STAFF REPORT: 07/09/2025 REGULAR MEETING

APPLICATION NUMBER: HDC2025-00230

ADDRESS: 1039 SEYBURN

SCOPE: MULTIPLE EXTERIOR ALTERATIONS

Photos from application

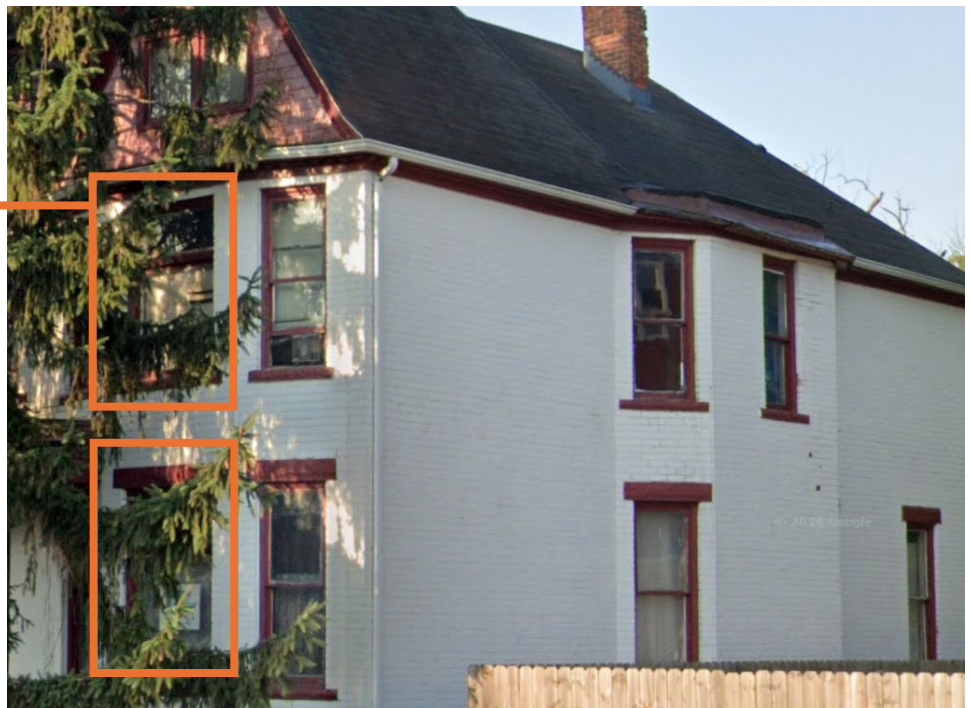
- The applicant proposes to replace any crumbling brick with “reclaimed common brick” and to tuckpoint where there are areas of missing mortar, though applicant does not specify the type of mortar that will be used.

- It is staff’s opinion that this work item is generally appropriate with the condition that the applicant consult the NPS’ guidance on tuckpointing historic masonry (see [Preservation Brief 2: Repointing Mortar Joins in Historic Masonry Buildings](#)) and identify a product that is of an appropriate composition/that matches the strength of existing historic mortar. An off-the-shelf mortar product would not be appropriate for a house of this age.

- Specifications for the glass transparency level
 - Specifications of the opacity of the screens
- A historic mortar mix shall be used for the proposed tuckpointing, as the mortar must be softer than the historic brick and match the composition of the existing historic mortar.

- A sample of the replacement brick shall be provided to staff for review and approval to ensure that it is suitable for exterior use and is compatible in texture, color, and dimension with the adjacent historic brick.

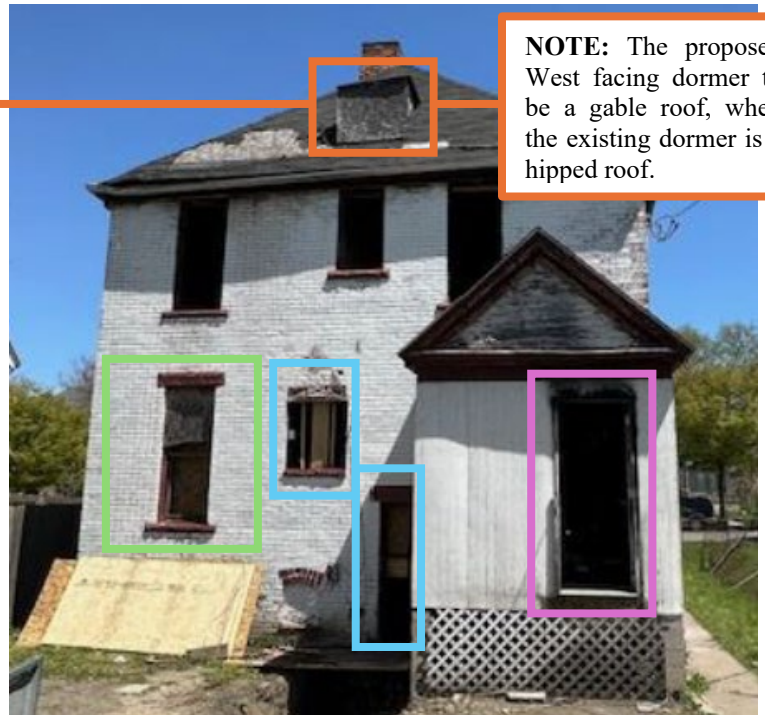
- Jeld-Wen W-3500 aluminum-clad wood windows with black exterior cladding.
- New double-hung windows to match profile and sizing to the rough opening of existing windows, including being cased with new brick molding.

- Per the drawings submitted on 05/22/2025, the proposed windows and doors are to keep their current opening dimensions, except for existing two window openings and one door opening to be altered.
 - Back (West) elevation window opening to be enlarged and replaced with a double-door.
 - The double-door product specifications was not included in the application materials. Staff requested specifications via email on 06/27/2025.
 - Back (West) elevation window and door opening to the right of the proposed double-door to be infilled with brick, though it does not correlate with the submitted drawings.

- A final window order shall be submitted to staff for review, which includes:
 - Transom windows at the two centered bay windows at the front (East) façade

Back (West) elevation drawing and photo from application

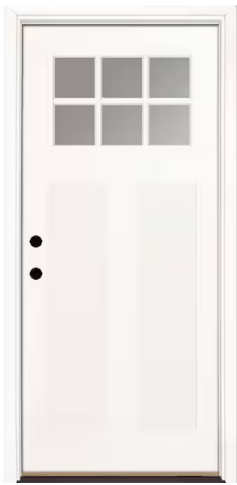
NOTE: The proposed West facing dormer to be a gable roof, when the existing dormer is a hipped roof.

- A new design for the back and front doors, research porch/deck and railing, and front porch roof and railing shall be selected and submitted to staff for review and approval.

Front (East) elevation drawing from application

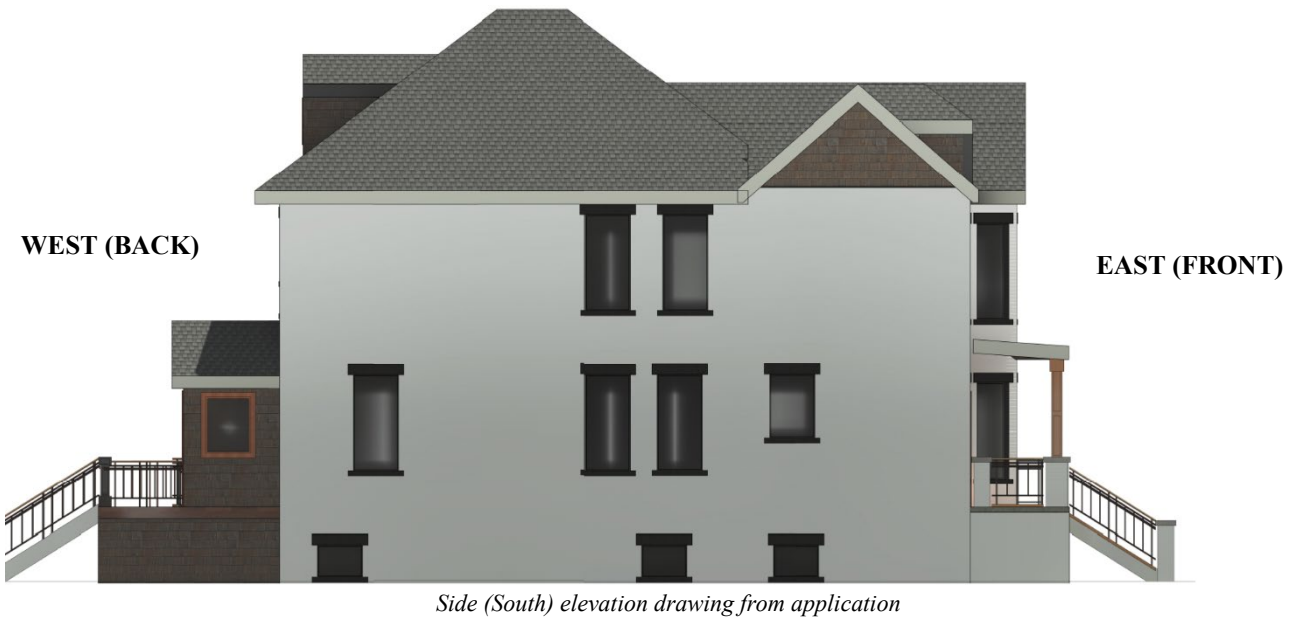
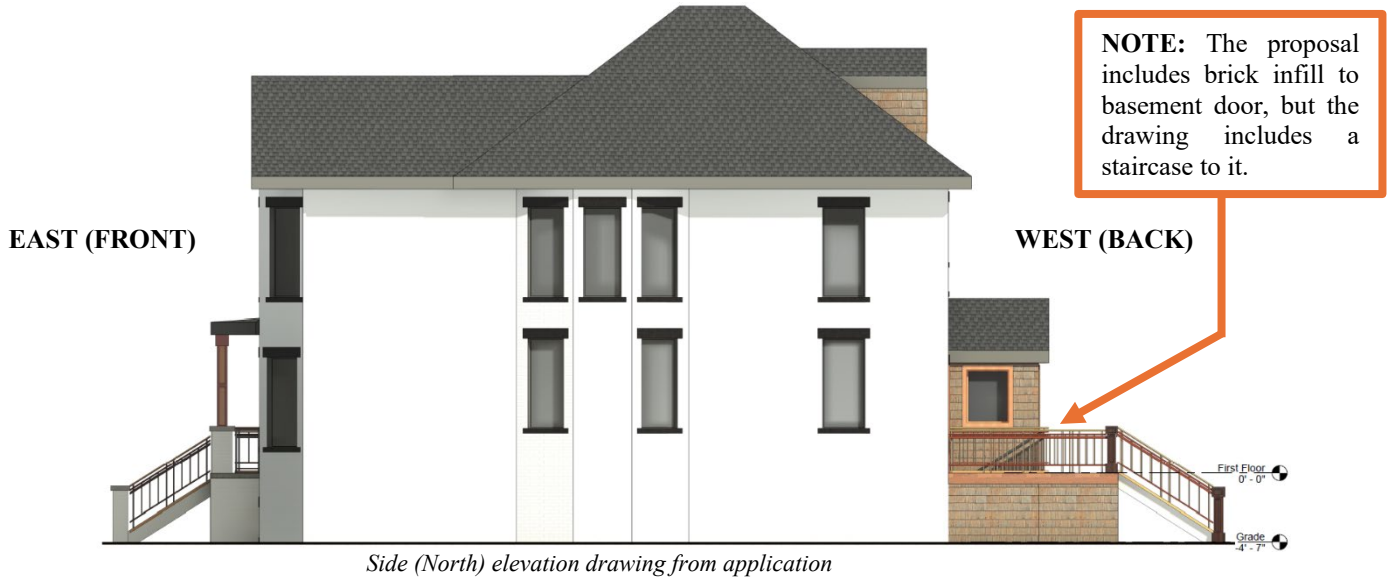
- Masonry front porch to be rebuilt, complete with reclaimed brick walls and new slab. Dimensions remain unchanged.
- The applicant proposes a "new wood framed, shingled shed roof over rebuilt front porch" with the roof to match the dimensions of the porch.
- For the railing, the applicant proposes to "install new wood railing system and wood steps on front porch. ...Railing to measure 42" H." No additional detailing, including materials, were provided.

- With Google Street View in 08/2018, right before the fire, you can see the historic porch roof detailing remained. Also, the porch supports were non-historic, C. 1970's metal columns. However, the fire destroyed the front porch roof and columns, while the porch deck and floor remained.

- The current application lacks a dimensioned floor plan for the rear porch/deck.
 - With respect to the front porch, it is staff's opinion that the proposed height (42") and design and materiality of the railings (likely metal balusters) is not compatible with the property's historic appearance. A simple wood railing with square balusters of an appropriately lower height is recommended. Also, while the replication of the original porch roof is not required since it was destroyed by the fire, staff does recommend that the new porch roof borrow some design cues from the original porch to ensure that it is compatible with the historic character of the house and the contemporaneous houses within the district. It is staff's opinion that the current design presents a wholly modern appearance that is not appropriate for a front porch of a Queen Anne style house. See the photos below of examples of front porches in the near vicinity and note that multiple houses on Seyburn between E. Lafayette and Agnes still showcase historic porch detailing at the cornice combined with simple, thick wood posts.
